ceined by Och; Appropriate 18:120:35 AM Office	State of New Mexico	Form C-1031 of
District I – (575) 393-6161	Energy, Minerals and Natural Resources	Revised July 18, 2013
1625 N. French Dr., Hobbs, NM 88240		WELL API NO. 30-025-25708
<u>District II</u> – (575) 748-1283 811 S. First St., Artesia, NM 88210	OIL CONSERVATION DIVISION	5. Indicate Type of Lease
<u>District III</u> – (505) 334-6178	1220 South St. Francis Dr.	STATE X FEE
1000 Rio Brazos Rd., Aztec, NM 87410 District IV – (505) 476-3460	Santa Fe, NM 87505	6. State Oil & Gas Lease No.
1220 S. St. Francis Dr., Santa Fe, NM	,	0.5 5 6.6 6.6 6.6 25 25 25 1.6.
SUNDRY NOTICES AND REPORTS ON WELLS (DO NOT USE THIS FORM FOR PROPOSALS TO DRILL OR TO DEEPEN OR PLUG BACK TO A DIFFERENT RESERVOIR. USE "APPLICATION FOR PERMIT" (FORM C-101) FOR SUCH PROPOSALS.)		7. Lease Name or Unit Agreement Name CENTRAL VACUUM UNIT

1. Type of Well: Oil Well Gas Well Other INJECTION		8. Well Number 081
2. Name of Operator		9. OGRID Number
MORNINGSTA	330132	
3. Address of Operator	10. Pool name or Wildcat	
	FORT WORTH, TX 76102	VACUUM; GRAYBURG-SAN ANDRES

Action 359449

Operator:	OGRID:
MorningStar Operating LLC	330132
400 W 7th St	Action Number:
Fort

CURRENT **WELLBORE DIAGRAM**

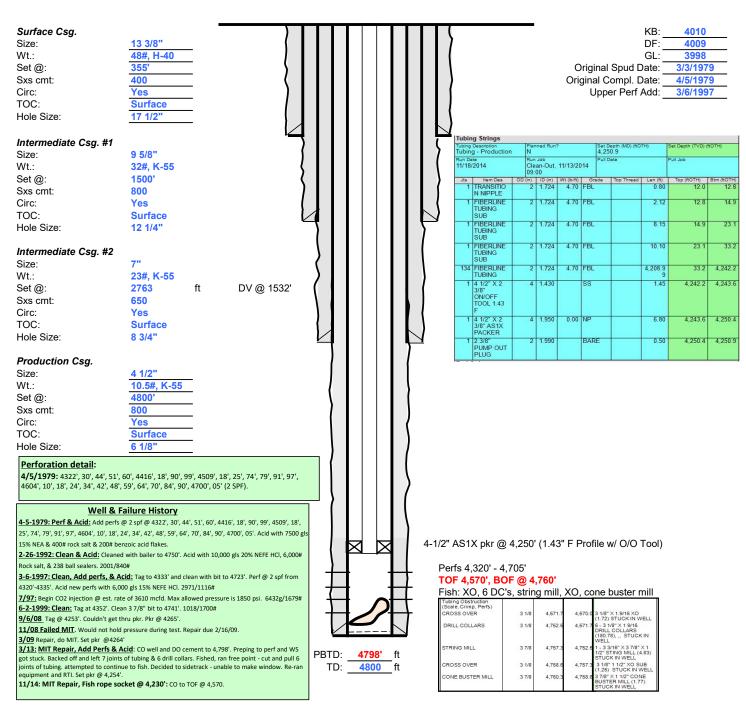
12. Check Appr	ropriate Box to Indicate Nature of Notic	e, Report or Other Data
	·	
NOTICE OF INTE		JBSEQUENT REPORT OF:
	LUG AND ABANDON REMEDIAL WO	
	· · · · · · · · · · · · · · · · · · ·	ORILLING OPNS. P AND A
	ULTIPLE COMPL CASING/CEME	ENT JOB
DOWNHOLE COMMINGLE		
CLOSED-LOOP SYSTEM OTHER:	☐ OTHER:	
		and give pertinent dates, including estimated date
	SEE RULE 19.15.7.14 NMAC. For Multiple (
proposed completion or recomple		completions. Attach wendore diagram of
MorningStar Operating requests an	pproval of the following procedure in response	to Violation cGR2414952977:
 Pull pkr and scan injectio 	on tha	
	o cleanout to ~4,570' (top of fish).	
	4,220' (within 100' of top perf at 4,320').	
5 1	e able to set pkr up to 3,879'. This is the top of	the unitized interval.

Created By		Condition Date
mgebremichael	The packer shall not be set more than 100 ft above the top of the approvedunitized interval (3858'-4858') by R-5530 and the same size tube shall be replaced as stipulated by the same hearing order.	7/24/2024
